# SERVICE BULLETIN REVISION NOTICE

NON-MODIFICATION SERVICE BULLETIN — ENGINE — INSPECTION OF THE NO. 5 BEARING COMPARTMENT (OIL JET) AND OIL TUBES FOR COKING

Turbojet Engine Service Bulletin No. V2500-ENG-72-0461 Revision No. 7 dated October 1, 2015.

## Reason for the Revision

OIL FEED TUBE THROUGH THE TEC STRUT  
REFERENCE 5, PRE SERVICE BULLETIN V2500-ENG-72-0063 TEC (A1)  
FIGURE 1

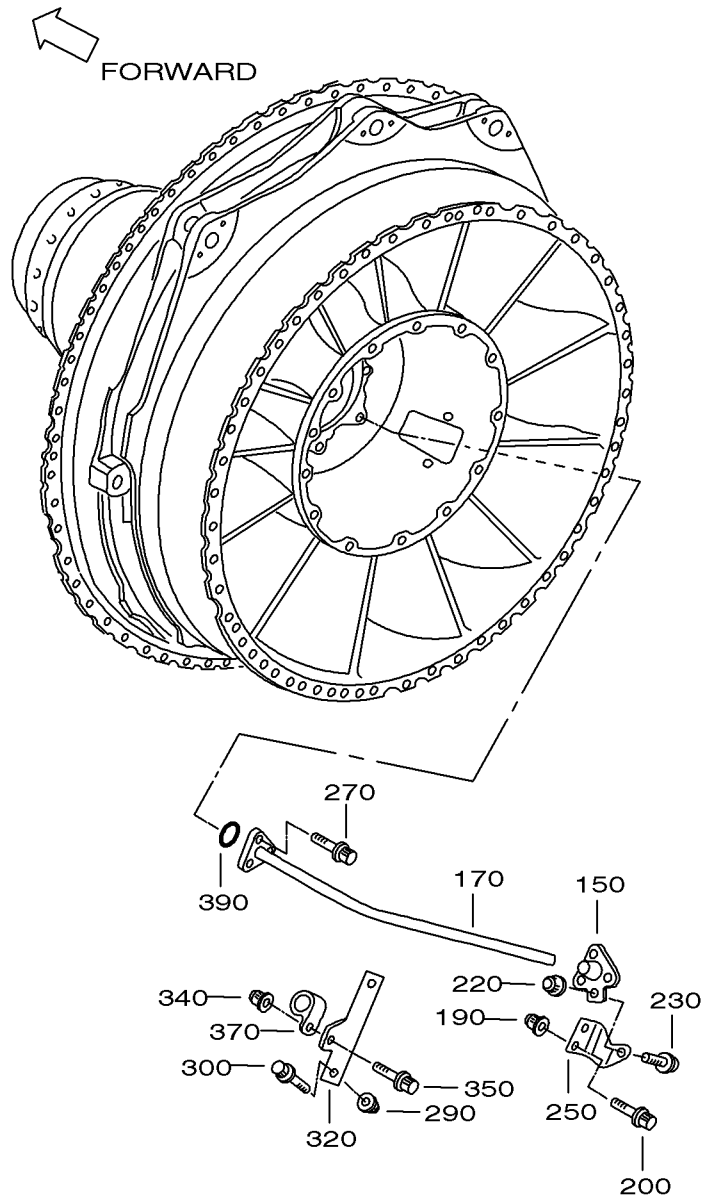
- (11) Using borescope equipment, examine ID bore of the oil feed tube (Figure 1, item 170) for evidence of coking.
  - (12) If no coke is present, then do steps that follow:

- (a) Connect external tube (Figure 2, item 100) using new packing (Figure 2, item 116).
    - (b) Connect internal feed tube (Figure 1 item 170) using metallic seal (Figure 1 item 390).

- (c) Install 3 bolts (Figure 1 item 270). Torque bolts in increments of 25 lbf-in (2.82 Nm) to 101.784 lbf-in (11.5 Nm).
    - (d) Torque the 3 bolts and nuts (Figure 2, items 114 and 110) to 85 to 95 lbf-in (9 to 10 Nm).

- (e) Install the clamp to the oil feed tube (Figure 1 item 370). Attach the clamp to the bracket with the bolt (Figure 1 item 350) and locknut (Figure 1 item 340). Torque to 17.701 lbf-in (2.0 Nm).

OIL SCAVENGE TUBE RUNNING THROUGH TEC STRUT  
REFERENCE 5, PRE SERVICE BULLETIN V2500-ENG-72-0063 TEC (A1)  
FIGURE 3

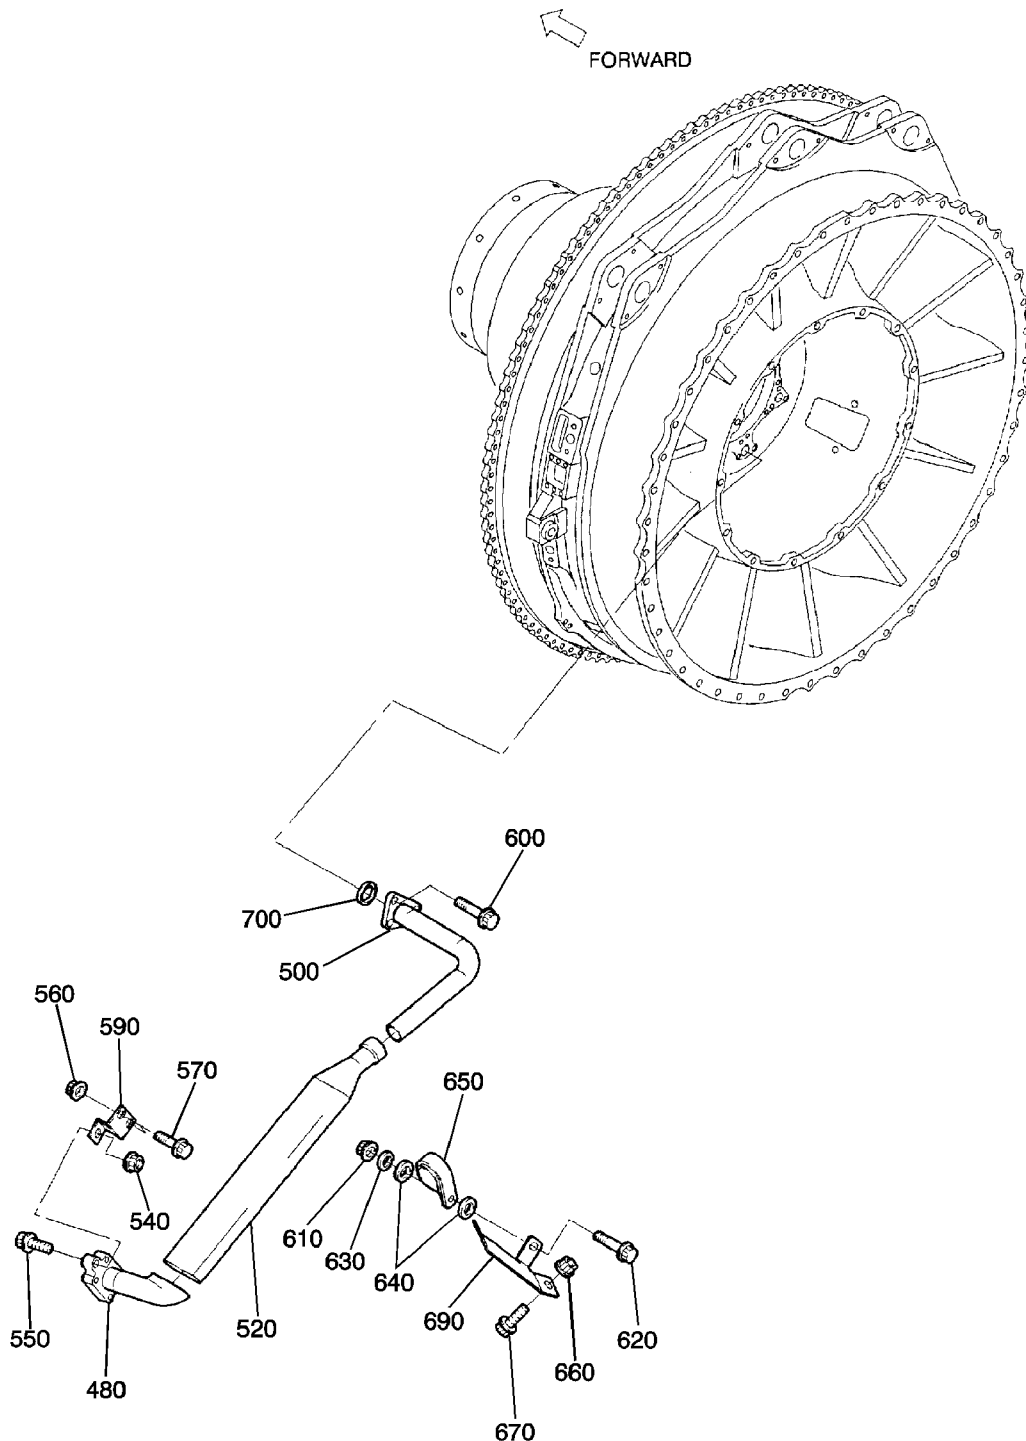
- (9) Using borescope equipment, examine the ID bore of the oil scavenge tube (Figure 3, item 520) for evidence of coking.
- (10) If no coke is present, then do the steps that follow:

- (a) Connect external tube (Figure 4, item 216) using new packing (Figure 4, item 117).
  - (b) Install metallic seal 1 off to the flange of the oil scavenge tube (Figure 3 item 700).

- (c) Install the three bolts which attach the oil scavenge tube to the No. 5 bearing compartment. Torque the bolts in increments of 25 lbf-in (2.82 Nm) to 101.784 lbf-in (11.5 Nm) (Figure 3 item 600).

- (d) Attach the clamp to the bracket with the bolt, washer, two spacers and Torque to 39.828 lbf-in (4.5 Nm) (Figure 3 items 610, 620, 630, 640).
  - (e) Install the bolts and locknuts which attach the oil scavenge tube to the bracket (Figure 3, items 540, 550, 560, 570). Torque to 101.784 lbf-in (11.5 Nm).

- (f) Torque the 4 bolts and nuts (Figure 3, items 540, 550, 560, 570) to 85 to 95 lbf-in (9 to 10 Nm).

SCAVENGE LINE FROM TEC STRUT EXIT  
 (A1/A5)  
 FIGURE 4

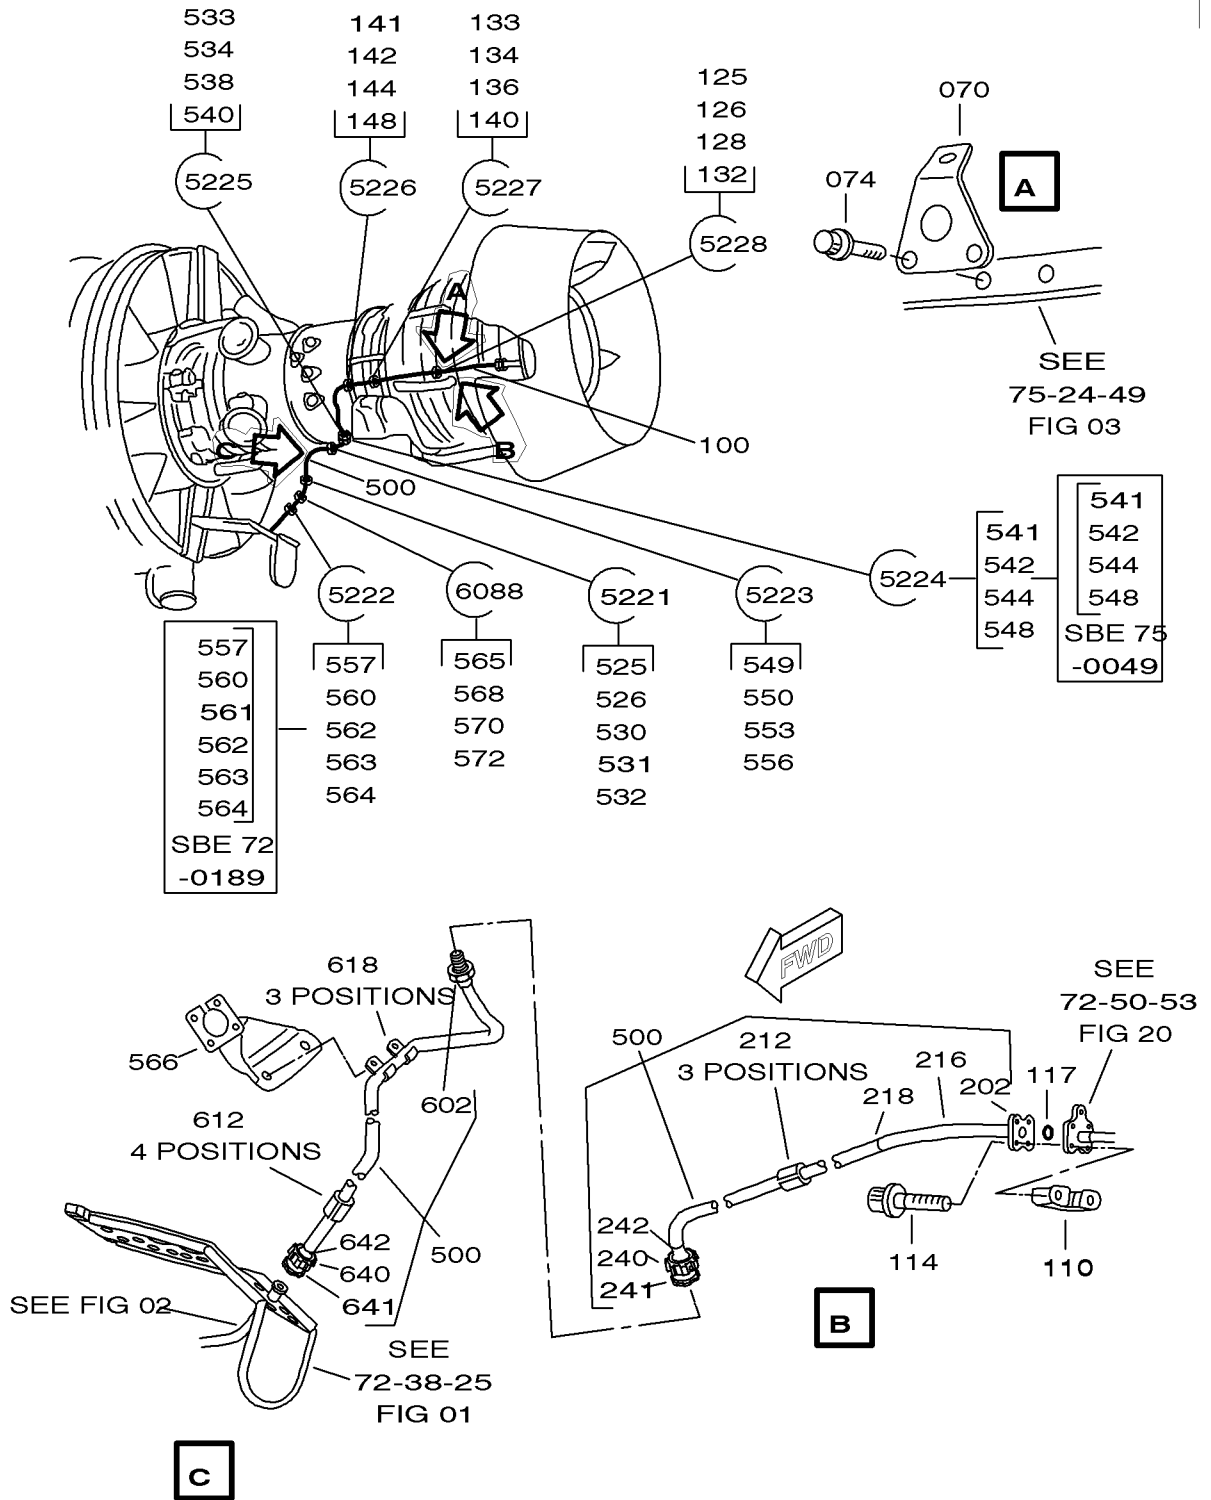
- (7) Remove and discard packing (Figure 4, item 117).
  - (8) Clean in situ per Appendix 1 procedure Method 1, or remove the engine from the aircraft and perform Reference 2, Engine Manual, Task 72-50-53-300-007, Repair 007, VRS5391.

NO. 5 BEARING OIL JET AND TRANSFER TUBE  
FIGURE 6

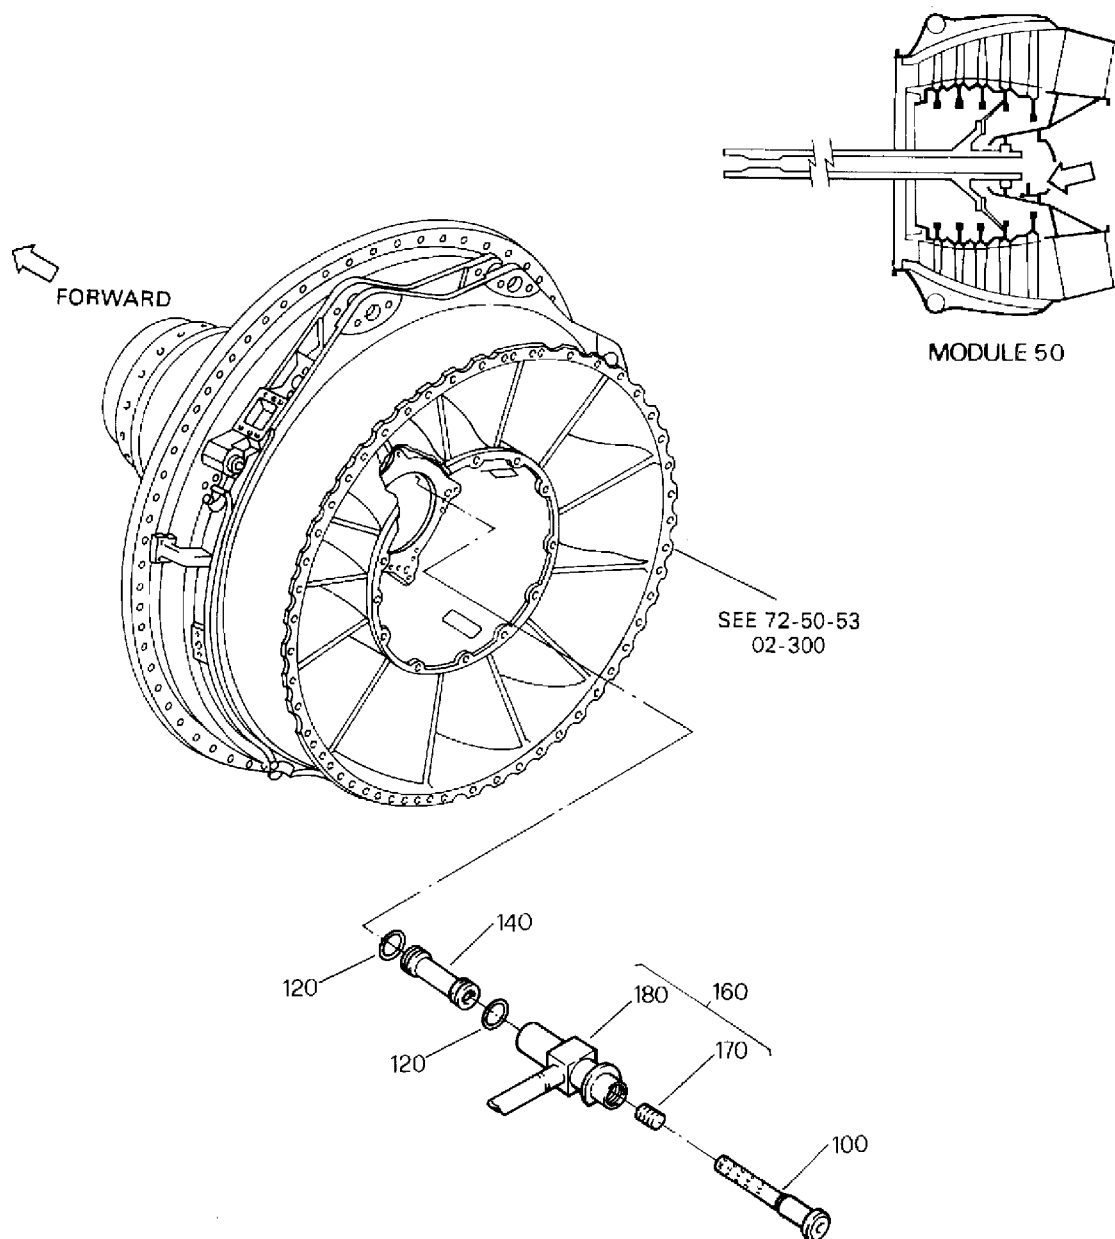
- (2) Remove, clean and inspect the No. 5 bearing oil jet assembly for coke/blockage (Figure 6):

- (a) Release and remove the oil filter from the oil jet. Use IAE 1P16426 Remove/Installation Driver 1 off.
- (b) Move the oil transfer tube rearward into the oil jet until the removal of the oil jet is possible.
- (c) Move the oil jet forward and disengage from the front flange of the No. 5 bearing compartment. Remove the oil jet.
- (d) Remove the oil transfer tube from the oil jet and discard the 2 seal rings.
- (e) Replace or clean in accordance with Appendix 1 procedure.
- (f) Inspect the ID bores of oil nozzle and transfer tube for coke/blockage. (It is recommended to use a borescope of appropriate size or other optical equipment suitable as possible to inspect ID bores).

- (b) Torque the bolts between 85 to 105 lbf-in (10 to 12 Nm).
  - (2) Install the No. 5 bearing oil jet and transfer tube (Figure 6) as follows:
    - (a) Install toroidal sealing rings 2 off on both ends of the oil transfer tube.

- (b) Install one end of the oil transfer tube into the ID of the oil jet. Push the transfer tube into the oil jet in order to permit the subsequent installation.

- (c) Install the oil jet and align the eccentric diameter with the hole on the front flange of the No. 5 bearing compartment.
    - (d) Push the transfer tube from the rear with IAE 1F10153 installation Rod 1 off until it is fully installed into the flange of the No. 5 bearing housing.

- (e) Install the oil filter into the threaded hole of the oil jet. Torque the oil filter to 371.736 lbf-in (42.0 Nm). Use IAE 1F10182 Removal/Installation Driver 1 off.

NO. 5 BEARING SUPPORT  
FIGURE 7, SHEET 1

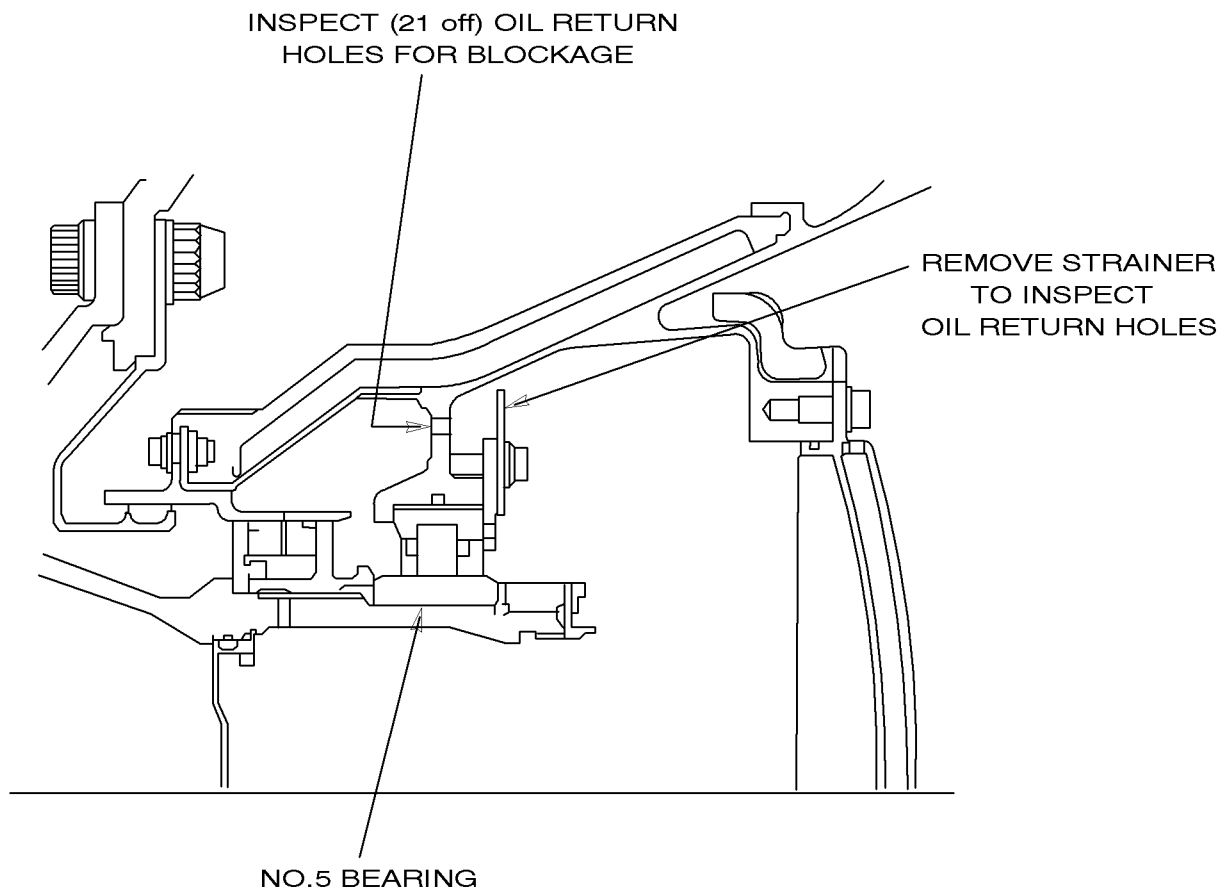
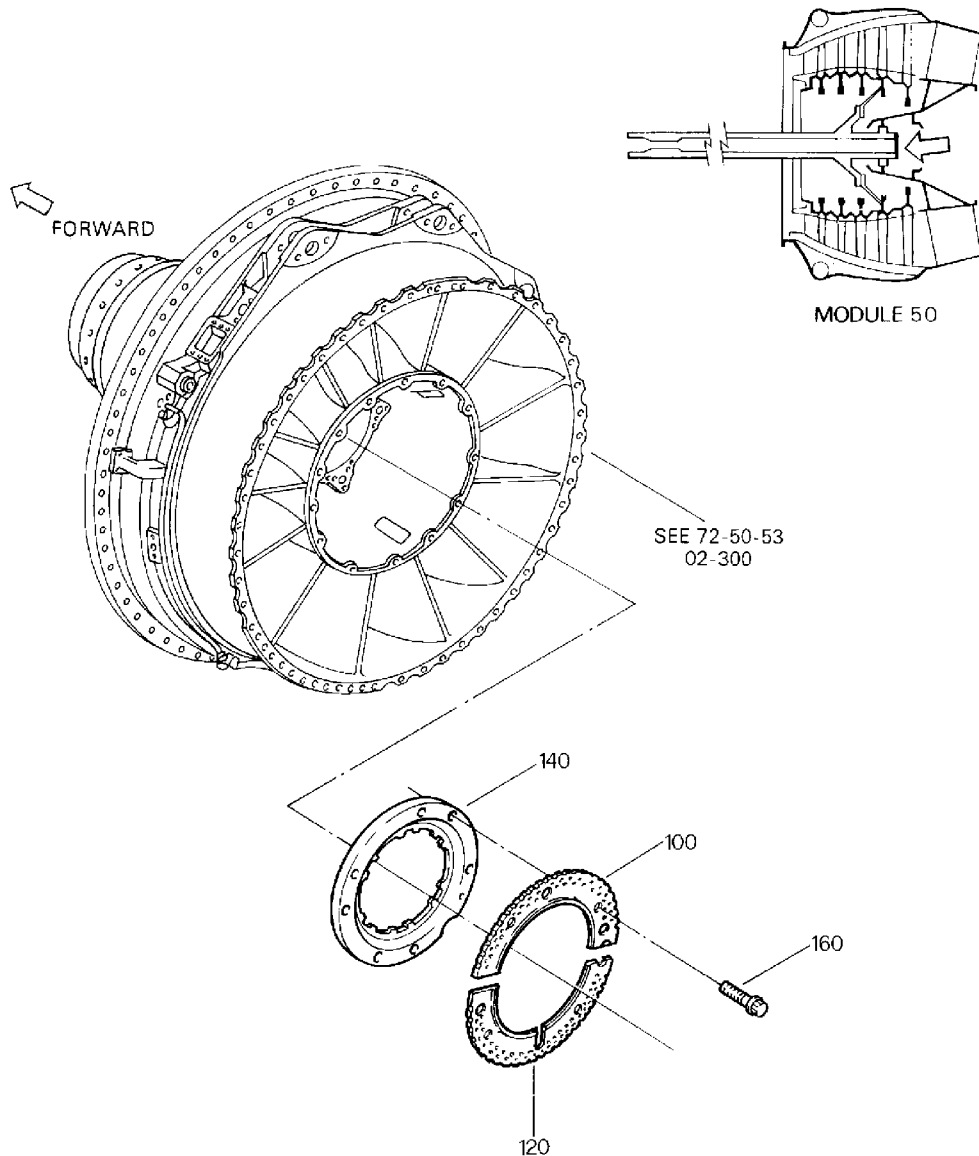
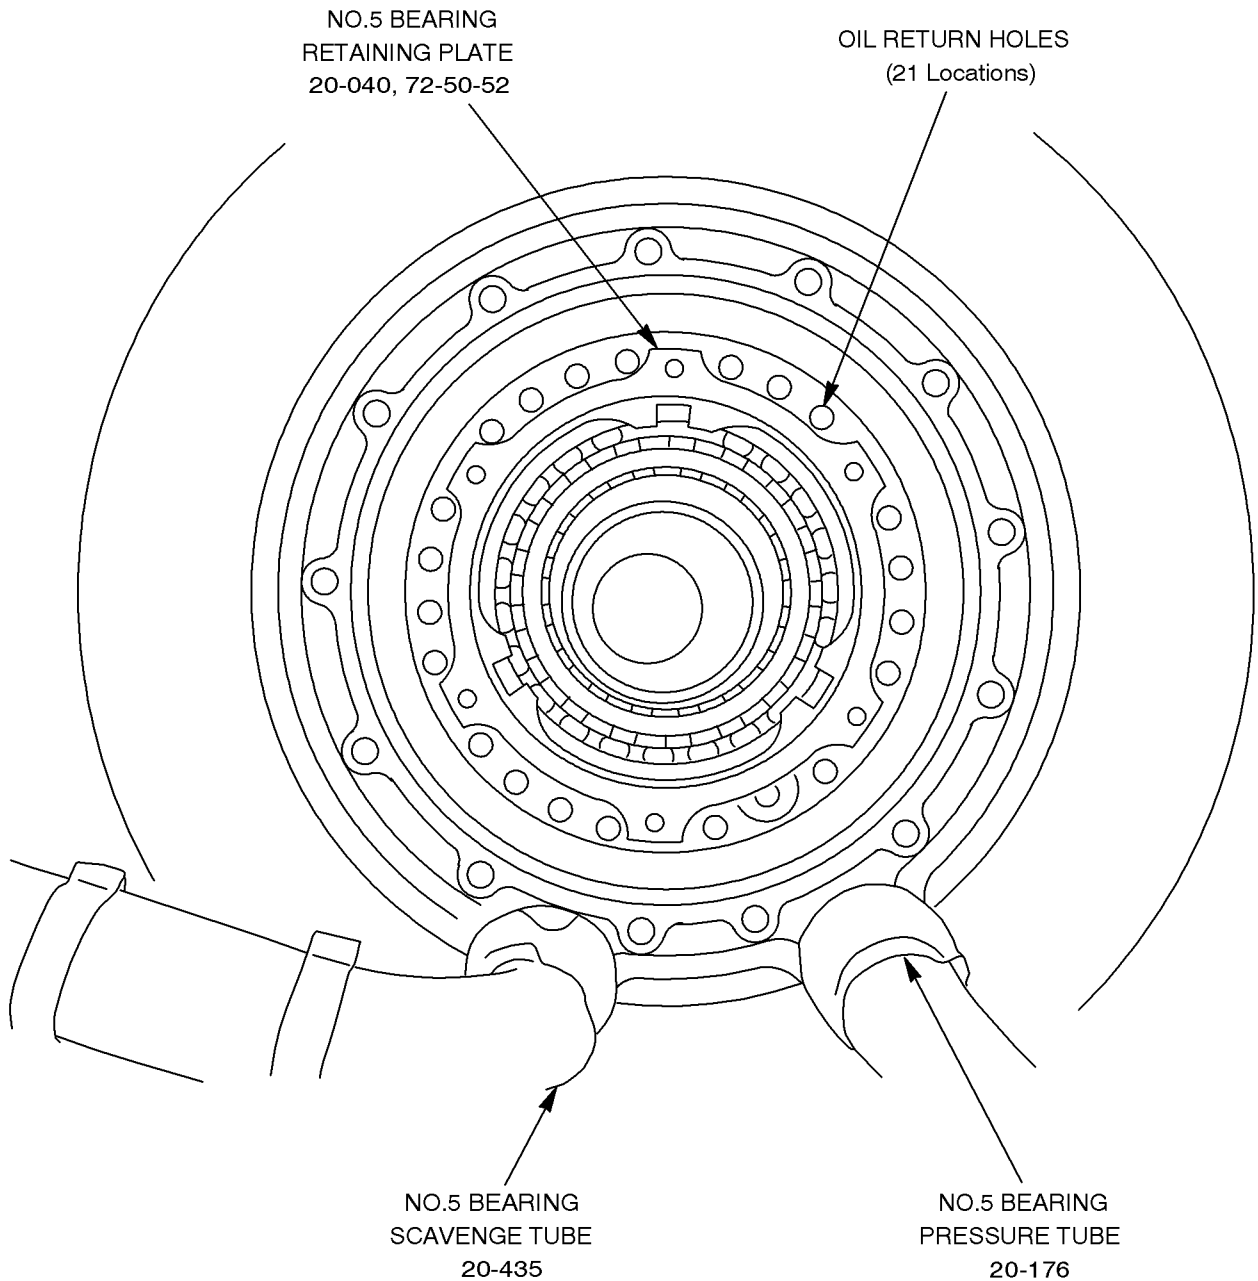
- (3) Inspection of No. 5 bearing support (Figure 7).

- (a) Remove the bolts which attach the upper and lower deaerator on the retaining plate to the No. 5 bearing housing.
- (b) Remove the upper and lower deaerator.
- (c) Inspect the No. 5 bearing support for blockage of oil return holes.

- 1 If the total area of holes blockage is equivalent to the area of at least two fully-blocked holes cleaning is required.

**NOTE:** If total area of hole blockage is equivalent to the area of at least two fully-blocked holes, proper scavenging of oil from the No. 5 compartment will be affected. This can cause oil flooding of the compartment, and result in oil leakage past the carbon seal, and subsequent tailpipe smoke or fire event.

- (1) Install the upper and lower deaerator on the retaining ring. Align the holes with the cutout on the ends over the oil feed port.
    - (a) Install the bolts which attach the upper and lower deaerator on the retaining ring.
